CERTIFICATE OF APPROPRIATENESS PLACARD

513 FLORENCE STREET

BOYLAN HEIGHTS

020-14-MW

Back Porch Stairs
513 Florence St.

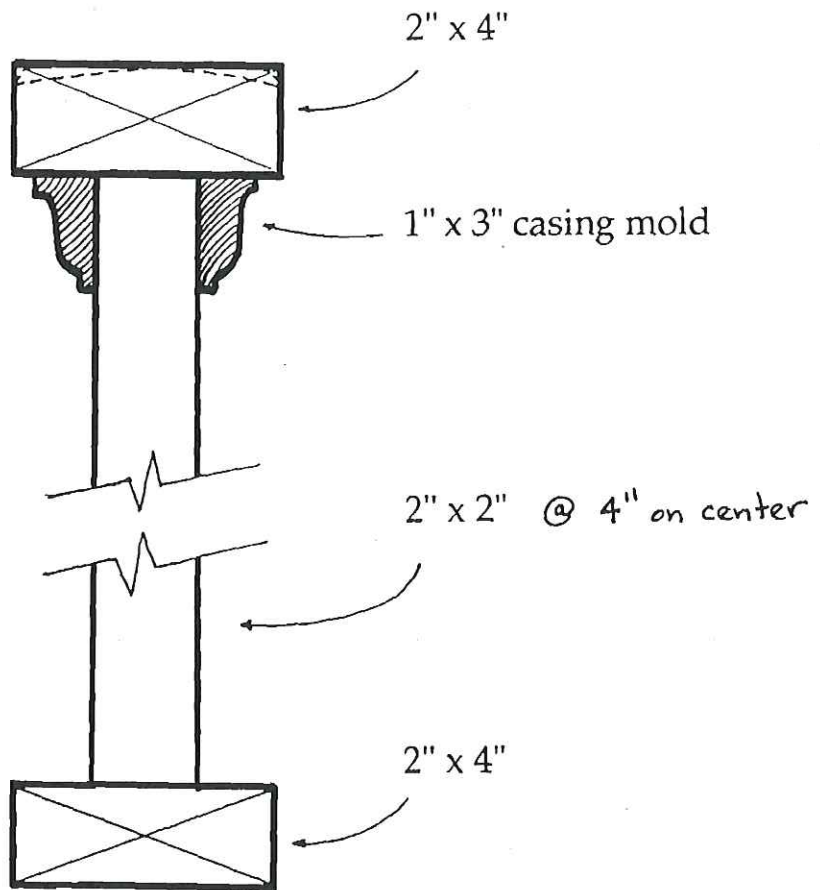
- design of the proposed new wood railing (see attached drawing samples for the kind of drawing(s) needed)

See two attached drawings. We'll be using the proposed sample design from the Raleigh historic commission.

Flat casing

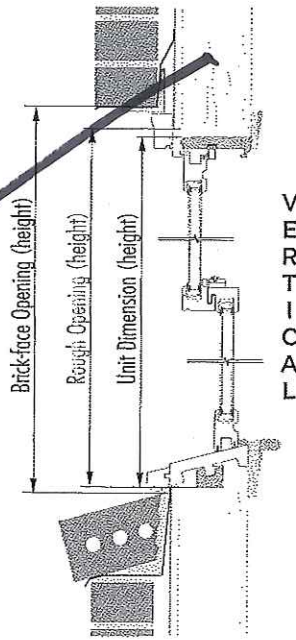
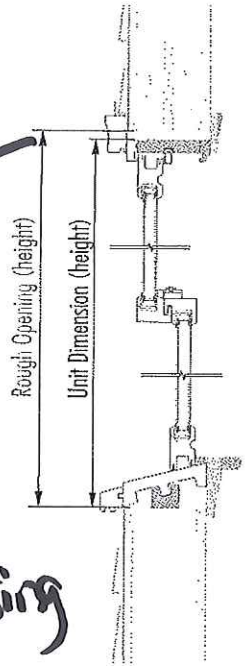
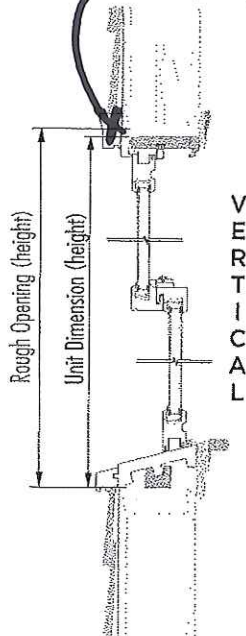
- The window information provided states that the exterior casing will be synthetic brickmould. This is not approvable. The exterior casing needs to be wood and be a flat trim piece. The synthetic sill is approvable.

Our contractor says he can replace the window we submitted with the same one, but made of wood instead of synthetic.

IMG_1288

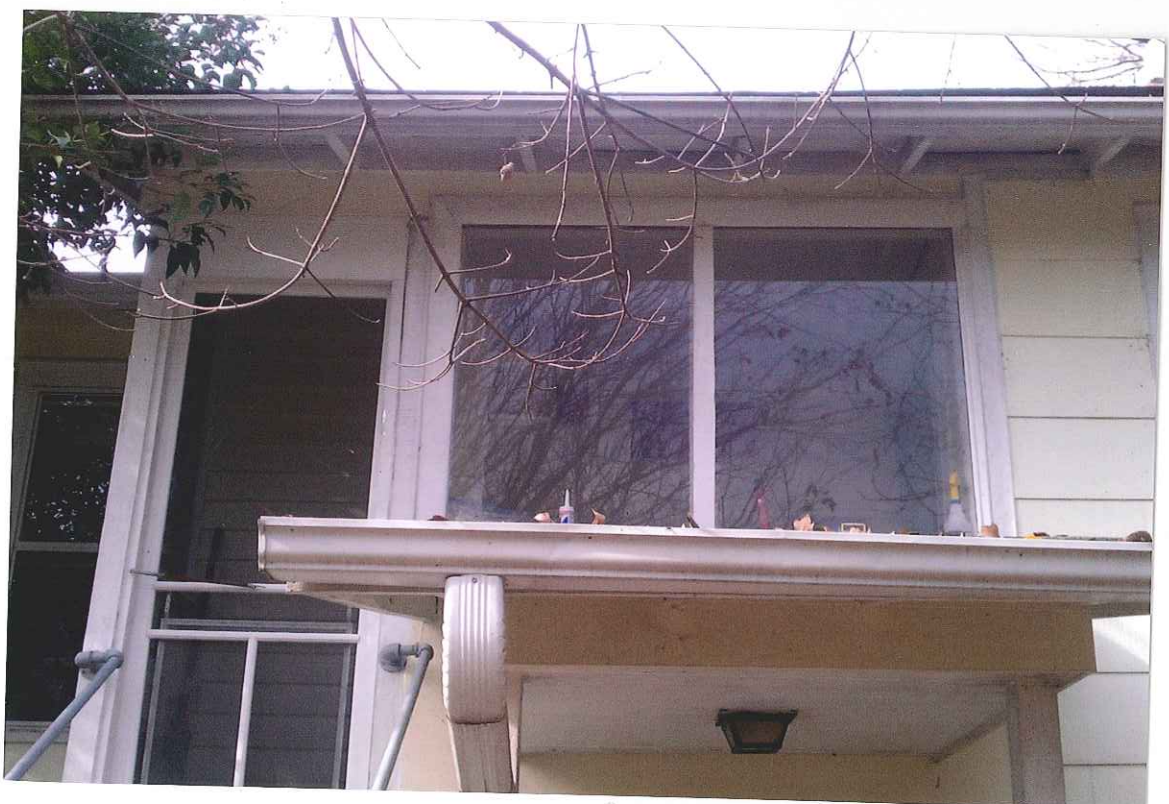
- additional photo(s) of the rear of the house that are farther back so as to see the whole area where the changes are proposed

See attached photo.
